**FINAL ALTERNATIVES ASSESSMENT
OF
INTERIM RESPONSE ACTIONS
FOR OTHER CONTAMINATION SOURCES
M-1 SETTLING BASINS
ROCKY MOUNTAIN ARSENAL
NOVEMBER 1989
CONTRACT NO. DAAA15-88-D-0022/0002
VERSION 3.1**

Enclosed are Shell Oil Company's comments on the Draft Final Alternative Assessment of Response Actions, M-1 Settling Basins, September 1989, Version 2.0. Shell's ARAR comments are being sent under separate cover today.

**RESPONSE TO SHELL OIL COMPANY'S COMMENTS ON DRAFT FINAL ALTERNATIVE
ASSESSMENT OF INTERIM RESPONSE ACTIONS, M-1 SETTLING BASINS
NOVEMBER 1989**

Figure 1-2 - DECISION FLOW CHART FOR
INTERIM ACTION VERSUS
MONITORING/MAINTENANCE
ON HOT SPOT IRAs

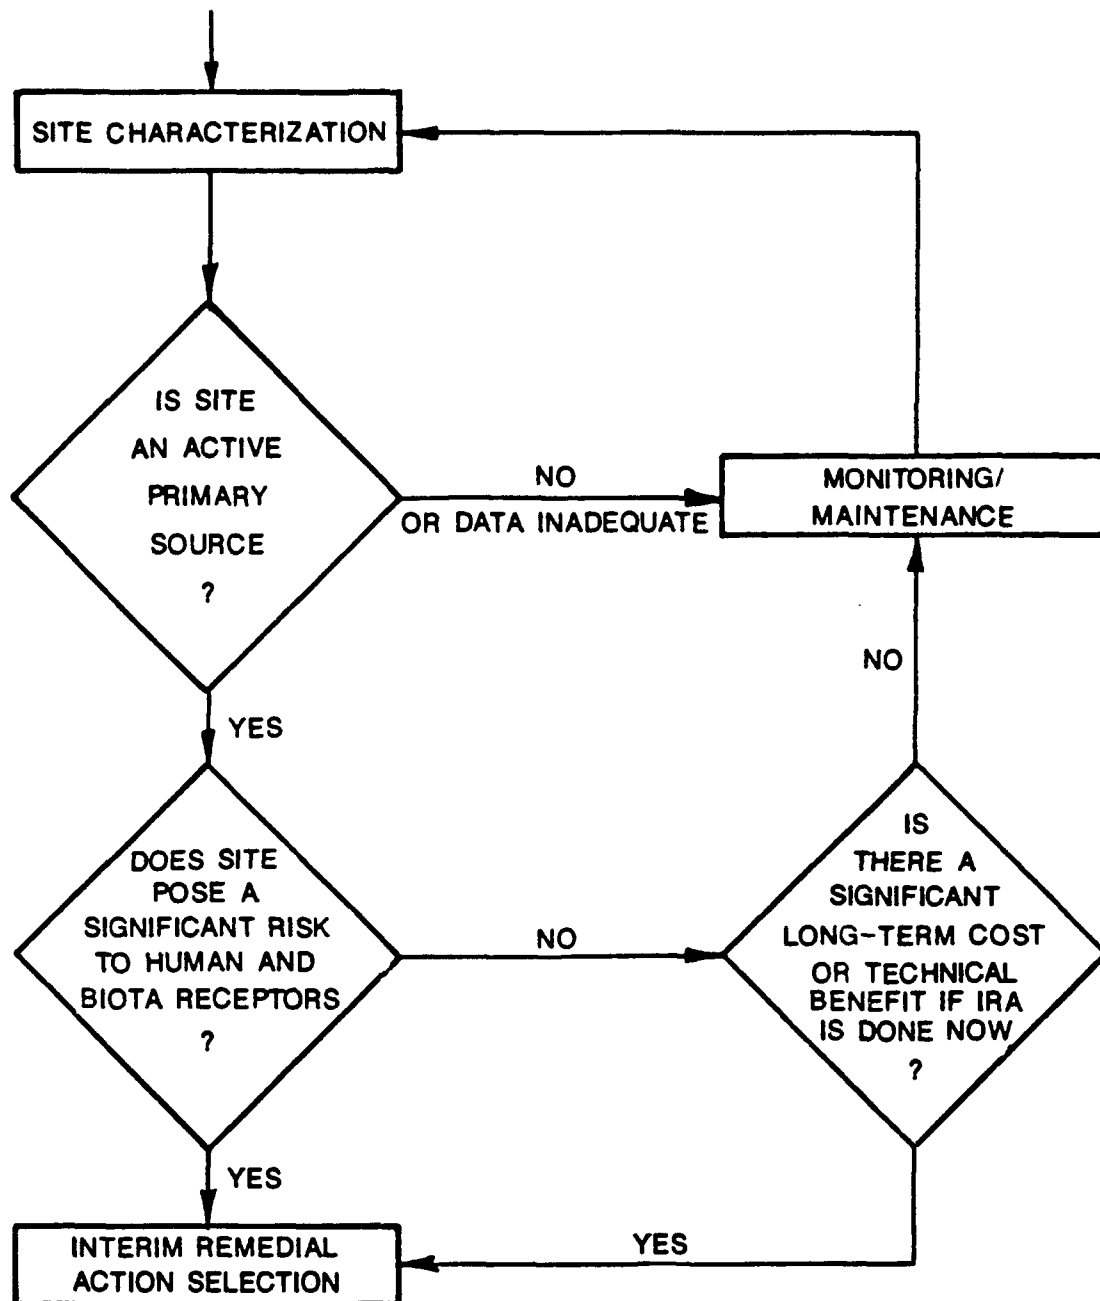
Comment 3: The Decision Flow Chart presented in this assessment (Figure 1-2) is an altered version of the Flow Chart actually agreed to by the Organizations and the State at the June 7, 1989 Other Contamination Sources Subcommittee meeting. Specifically, Data Inadequate should be on the NO leg of the first decision node, not on the YES node. The version agreed to is shown in Figure 1-1 of the final Technical Plan. This alteration appears to have misdirected this

Second, it was not agreed that if data are inconclusive or inadequate, a conservative approach would be taken. The agreement reached by the Organizations and the State in the June 7, 1989 Subcommittee meeting was that inadequate data would trigger the monitoring/maintenance action. Monitoring/maintenance may include further site investigation. The Decision Flow Chart in this assessment (Figure 1-2) is an altered version of the flow chart agreed to and which appears as Figure 1-1 in the Final Task Plan for Remediation of Other Contaminant Sources Interim Response Action. Specifically, the Data Inadequate decision path has been moved from

the NO to the YES pathway. Figure 1-2 of this assessment document should be replaced by the agreed to version. Data presented on this site are inadequate to assess the question of whether the M-1 Settling Basins are an active primary source of groundwater contamination. Accordingly, before proceeding with screening and evaluation of technology alternatives, further site investigation should be conducted.

Comment 1: Page 1-3 & 1-4 - The candidate selection criteria discussed on pages 1-3 & 1-4 do not accord with the flow chart presented as Figure 1-2. Specifically, the flow chart's initial diamond which presents the threshold question of whether the site is an active, primary source of contamination does not limit that question to an assessment of the site's effect on ground water. Such a limitation was expressly disapproved by State representatives at the June 7, 1989 subcommittee meeting which was held to discuss screening criteria for the "other sources" IRA.

Figure 2-1 M-1 SETTLING BASINS
FIELD INVESTIGATIONS

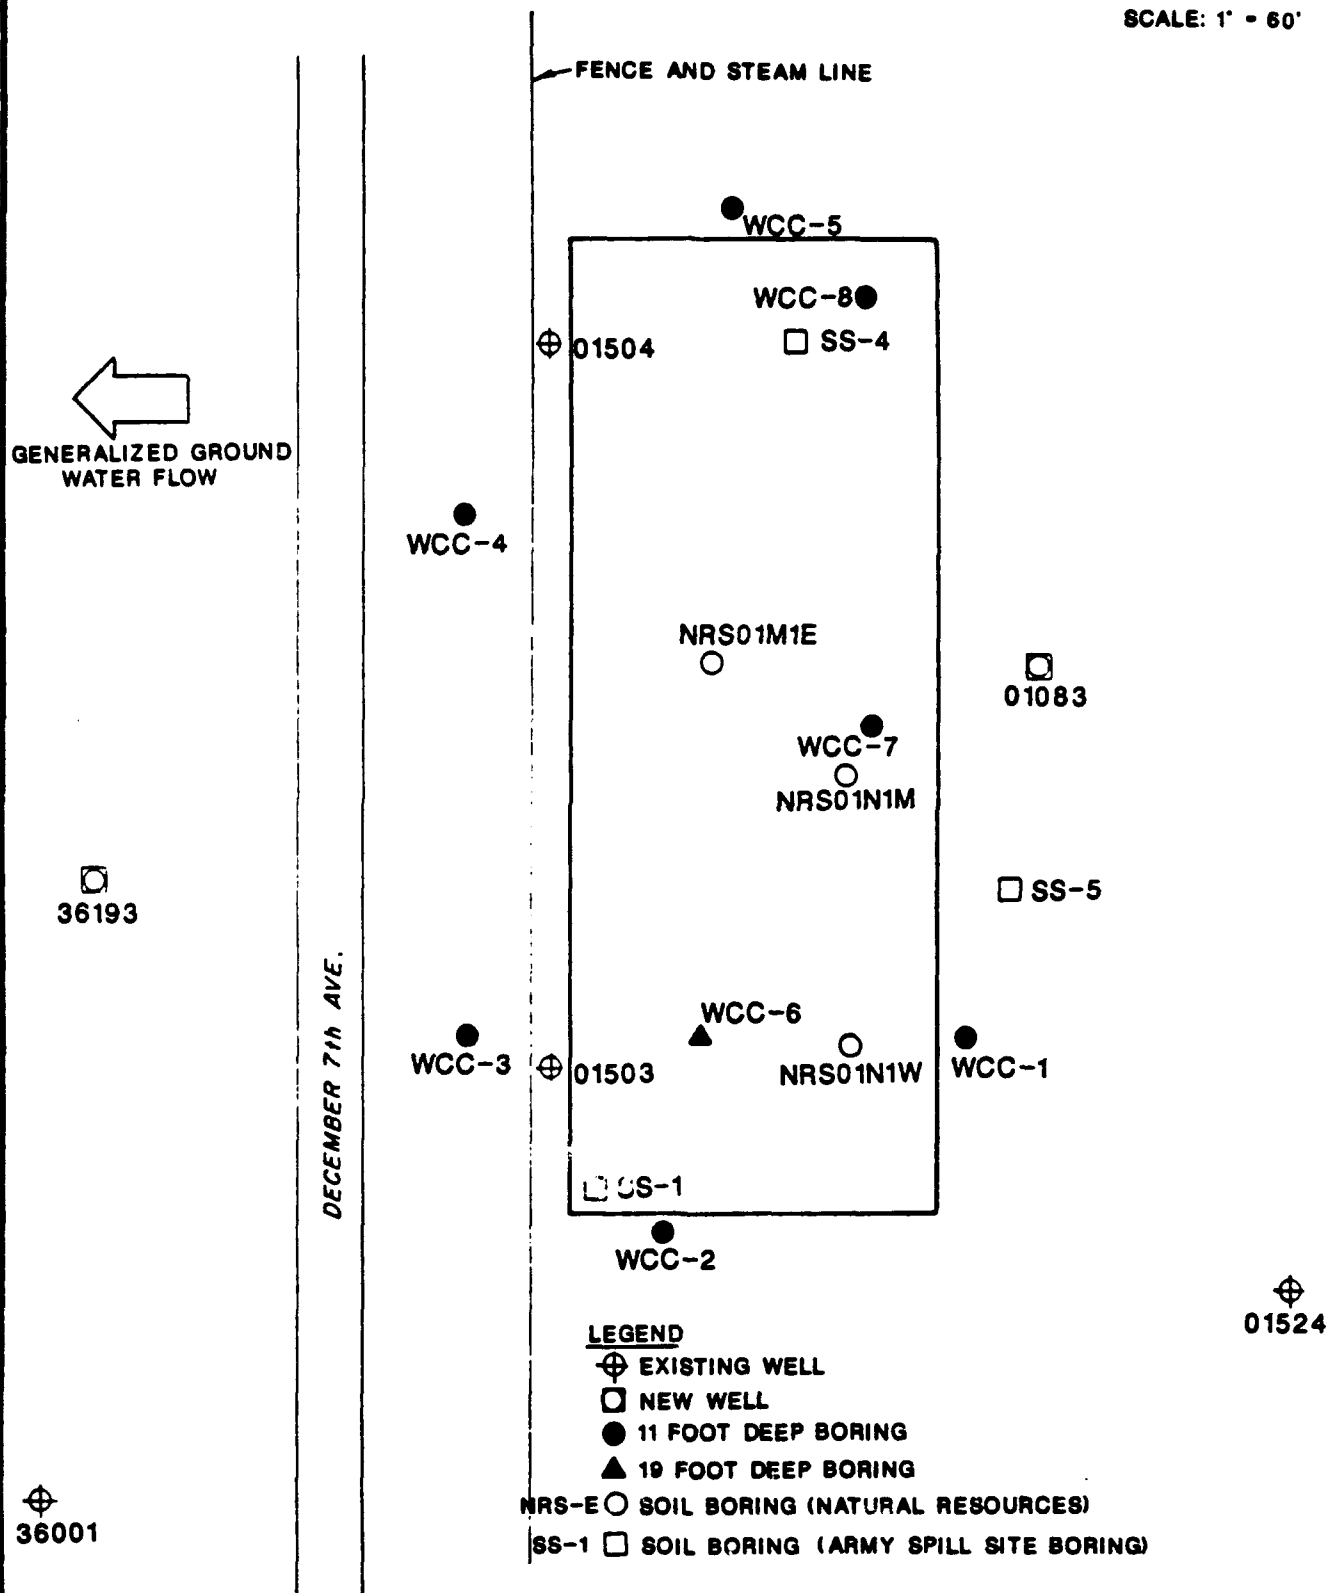
Comment 42: Figure 2-1, M-1 Basins Field Program.

B) The Alternative Assessment Document (page 2-4) states that six soil borings were completed in and around the perimeter of the M-1 Settling basins. However, the referenced figure (Figure 2-1) actually shows eight soil borings and there is no cross-referencing between the text and figure to clarify this discrepancy. The number system for the eight borings is also not consistent with the borings presented in the Army Spill Sites Report I (Plate 24S-1). Only three borings were completed in this study; two additional borings were not analyzed due to the presence of lewisite. Because basin perimeters are not marked on Plate 24S-1, it is difficult to determine coring locations with respect to the pits. However, it appears that only one boring (Boring 4) may have actually been completed within a basin. Nowhere in the text is there an indication that the bottom of any of the three basins was encountered.

The SPSAR states that only one of three borings in the Task 24 Army Spills program was completed. This contradicts the data presented in the Spill Sites Report. The SPSAR also states that additional borings completed by the Army and Shell (no reference given) were only completed to five feet below land surface, and did not reach the bottom of the basins. The soil boring locations presented in Figure SPSA 1.4-2 do not match either those presented on Plate 24S-1 of the Spill Sites Report, or Figure 2-1 of the Alternative Assessment Document.

(B) Figure 2-1 has been corrected to show the six soil borings drilled during previous investigations. Three were drilled during the Army Spill Sites investigation. The other three were drilled in 1986 and the data are in the RMA data base. The data from these borings are summarized in Table 2-1.
